Xavier Rixhon's PhD thesis - Answers to jury members - SHORT

Exploration of uncertainty-aware energy transition pathways -
Reinforcement learning and principal component analysis-based
methods

I would like to thank the jury members for their comments, which significantly helped improving the manuscript and substantiating the novelty of my work. Based on the notes taken during the private defense, I hereby answered, as accurately as possible, the jury's comments.

Figure 1: Storage installed capacities for the REF case

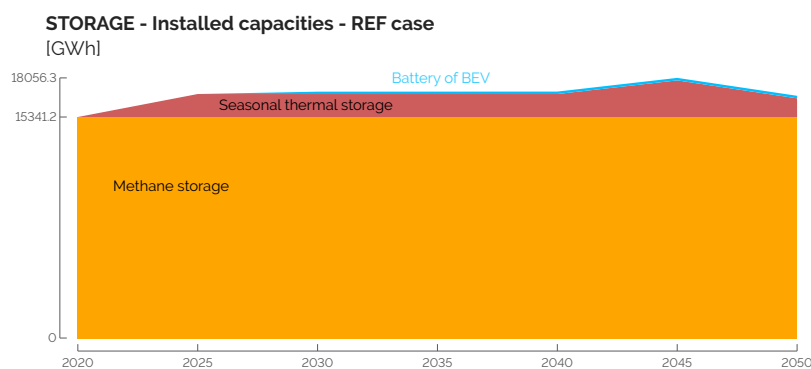
Stefan - Some big topics are missing like storage. Why is storage not more discussed?

As discussed during the private defense, storage is not more discussed in the manuscript for one main reason: the lack of variation through the pathway and under uncertainties. The storage technologies, for the case of Belgium assuming a copper-plate approach, consist in two main technologies: methane storage mostly (about 15 TWh) and, to a smaller extent, seasonal thermal storage (about 3 TWh), with limited variations through the transition (see Figure 1). Even though there is no limitation on the yearly quantity of methane (fossil or e-methane), for each representative year, the model is constrained to import the same quantity for each hour of each typical day. For this reason, the model decides to install methane storage that is emptied during the winter and refilled during the summer, as methane is mostly used to produce heat. Analyses under uncertainties have not shown major variations either. Moreover, storage assets are intrinsically linked to the conversion technologies and, consequently, can be seen as by-products of the optimisation results. For these reasons, I have rather focused my analyses on the use of resources and the installation and operation of conversion technologies. Given the discussion during the private defense and these further explanations, I have not brought modification to the manuscript in this regard.

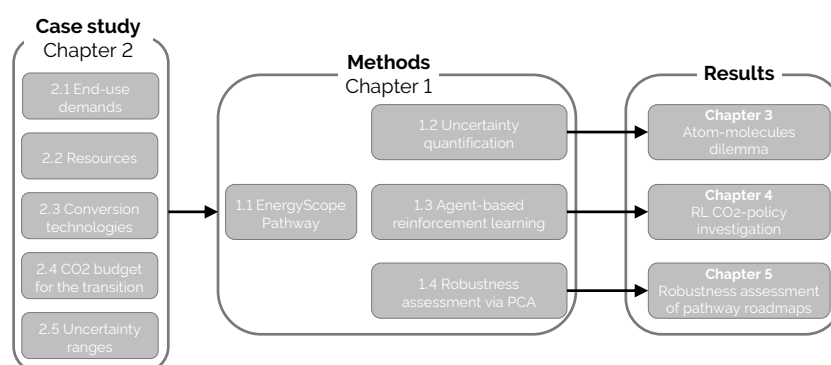
Stefano & Stefan - The thesis structure makes it quite difficult to follow. Having all the methodology summarised in Chapter 1, makes it difficult to link it to the different chapters. As changing the structure may be now a major work, I would invite you to think how to better connect the different parts.

Finally, I have added a schematic at the end of the Introduction of the thesis to clarify the structure and highlight that Chapters 4 and 5 can be read after the methodological sections 1.3 and 1.4, respectively (see Figure 2).

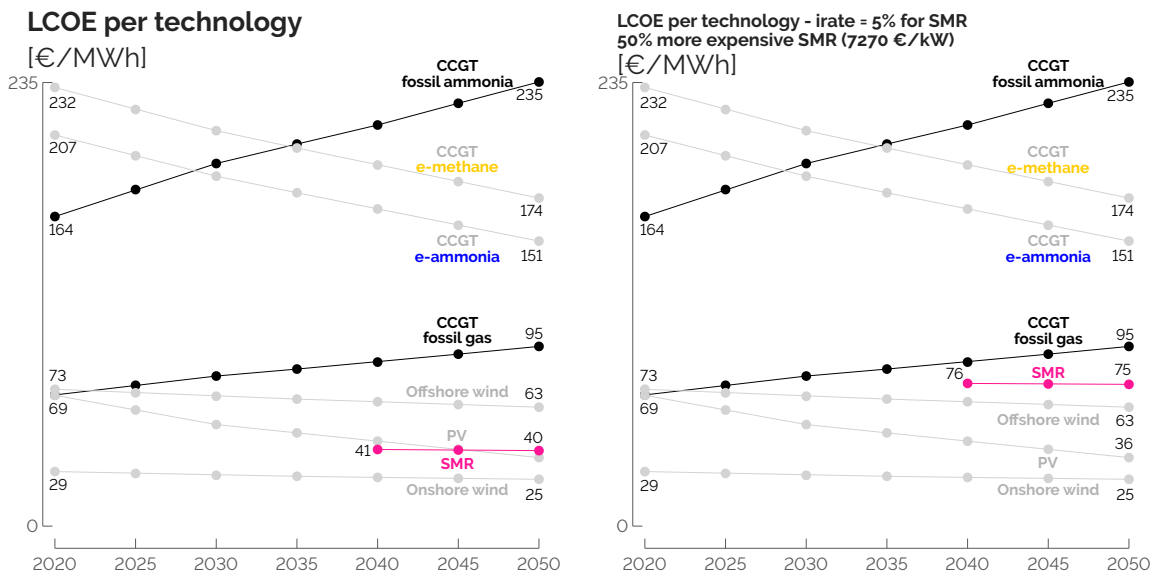
Stefano - Would it be fair to say that the scope of this Chapter is adding one technology (SMR) to the model? Is this a significant contribution?

On top of the uncertainty applied to the CAPEX of SMR [-40%, 44%] considered in the thesis, I carried out a test on these assumptions by plotting the LCOE of electricity-production units considering different assumptions for SMR (see Figure 4.2). Even considering 50% more expensive SMR subject to a higher discount rate (5% versus 1.5% for the other technologies), we notice that SMR keeps on being more cost-competitive than other flexible production units, like e-ammonia CCGTs, that are substituted by SMR when the latter can be installed (see Chapter 3). In other words, it means that the optimistic values assumed for SMR in the thesis lead to a cheaper whole-energy system but do not affect its design, i.e., the installed technologies. Consequently, no further modification has been brought to the thesis regarding this comment.

Besides having added SMR to the model which is one of the contributions regarding the case study (Chapter 2), the main contributions of this chapter is the global sensitivity analysis (GSA) performed on the optimisation of the transition pathway of a whole-energy system with 34 uncertain parameters. When applied to the case study of Belgium, this analysis also allowed to highlight the competition between SMR and some of the imported electrofuels (mostly e-ammonia and e-methane) by 2050.

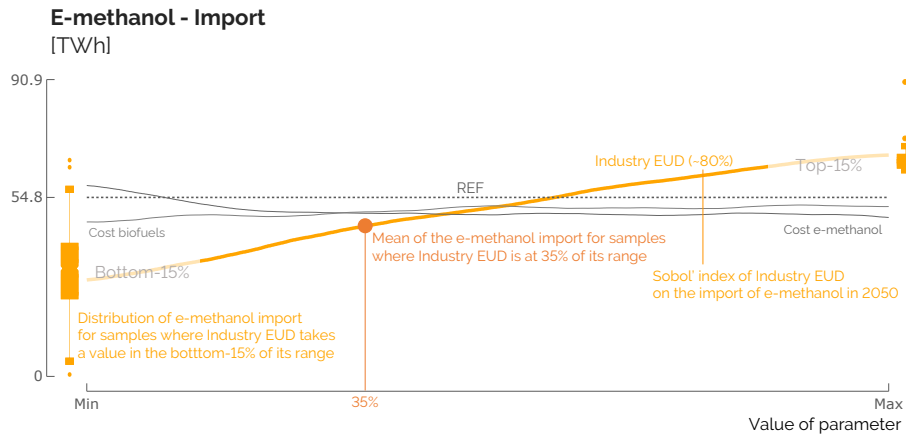
Stefano - p. 74 - Figure 3.8: this graphs looks potentially interesting but it is not sufficiently well explained.

The objective of this set of figures is to point out the key parameters that drive the variation of some outputs of interest. Taking the case of Figure 3.8, we focus on the import of e-methanol in 2050. On the x-axis, we represent the value taken by the uncertain parameters in the different samples. As the range is not the same for all the parameters, we have limited this axis from "Min" to "Max". The y-axis represents the feature of interest. The drawn lines represent average trend lines between the output of interest and one specific parameter. For the case of Industry EUD, for samples of the GSA where this uncertain parameter is at 35% of its range, the mean value of methanol imported in 2050 is roughly 50 TWh. The distributions present on the extreme left and right of the graphs correspond to the distributions of the output of interest for the samples of the GSA where the considered parameter takes a value in the bottom (left) or top (right) 15% of its range.

To improve the readability of this figure, I have updated the text zones to specify that these lines and distributions represent results of some specific samples of the GSA. Additionally, I have added a text zone to remind that the value between brackets is the Sobol' index of the considered parameter regarding this specific output of interest, and added this information in the caption of the figure:

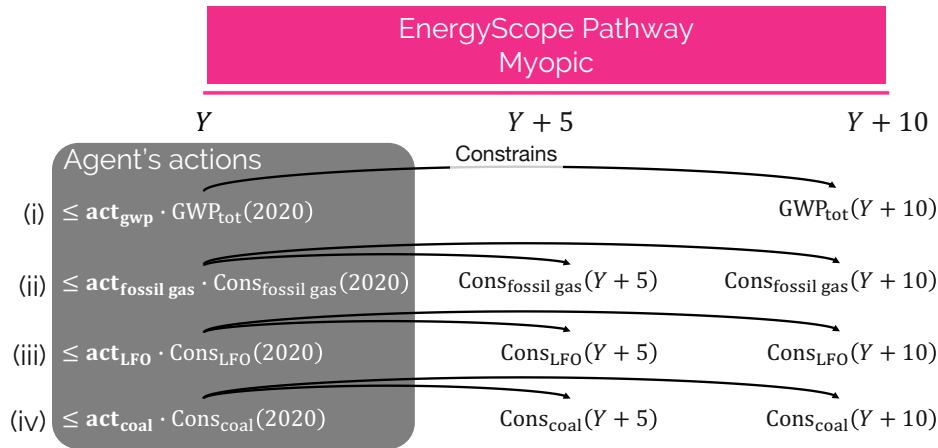
Stefan - Justification of the RL actions selected? why no other actions like the cost of some technologies?

Complementary to the text in the core of the manuscript, I have added a diagram to detail the agent's actions and how they impact the model: taken at the beginning of the time window to optimise (year Y), the four actions impact (i) the emissions of the system at the end of the time window (year $Y + 10$) and, (ii-iv) the consumption of fossil gas, LFO and coal at years $Y + 5$ and $Y + 10$.

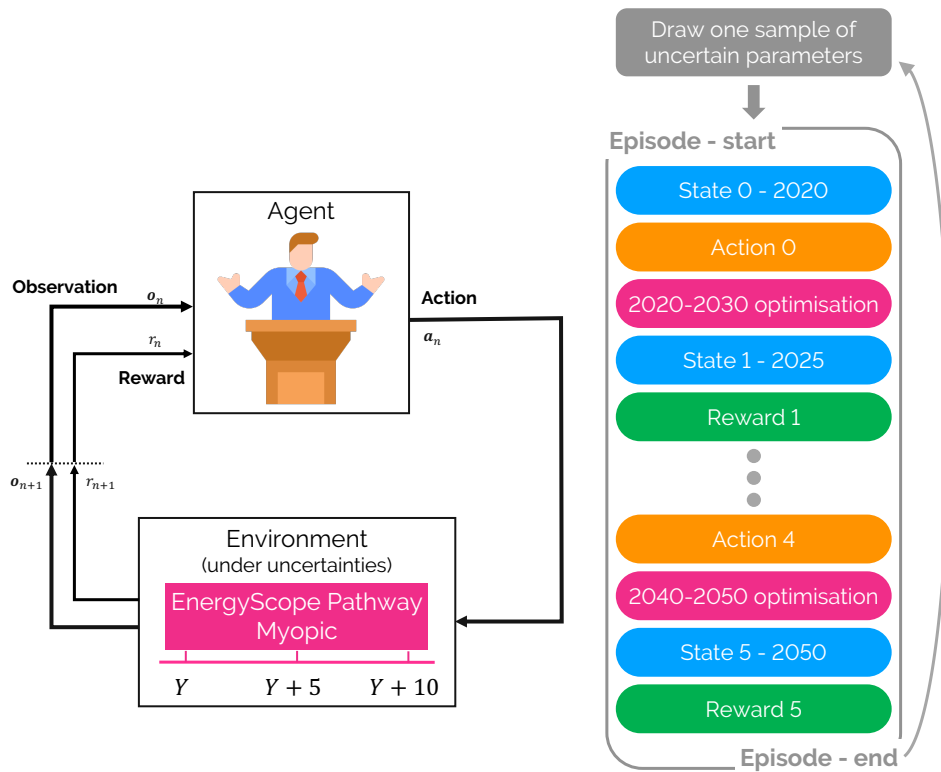
Stefano - Explain more in details the different steps in the RL approach.

Both, agent’s actions and exogenous uncertainties, change the value of some parameters of EnergyScope Pathway. However, where the sample of uncertainties is drawn once and for all at the beginning of the episode as explained in Section 1.2.1, the agent’s actions are taken at the beginning of each 10-year time window. This is now clarified [at the beginning of Section 1.3.2 and the updated version of Figure 1.7, and its caption](#) (see Figure 6 in the present document):

Before starting an episode, a sample of uncertain parameters is drawn and affects the environment, EnergyScope Pathway, according to the methodology detailed in Section 1.2.1.

Besides the general concepts/fundamentals detailed in Section 1.3.1, the application of the RL approach on the myopic optimisation of the energy transition of a whole-energy system is detailed in Section 1.3.2. Now, Figure 1.7 has been updated to clarify the difference between the uncertainty of parameters and the agent's actions as well as the interactions between the RL code (action, state, reward) and EnergyScope Pathway (optimisation of the concerned 10-year time window). I have also added a diagram to explain the impact that the agent's actions have on some parameters of the model.
